## ORIGINATION FORM

### Proposed Revisions to a Standard Plans Index

Index Number: 700-011

Index Title: Single Column Cantilever Ground Mounted Sign

SIGN DETAIL

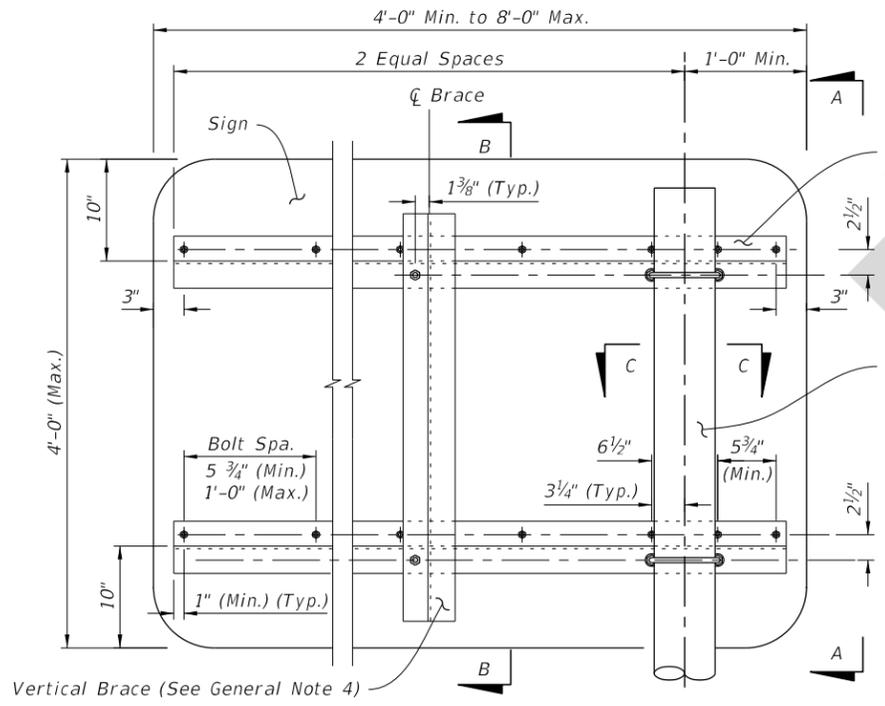
Updated General Note references in the SIGN DETAIL, VIEW A-A, SECTION B-B, and SECTION C-C.
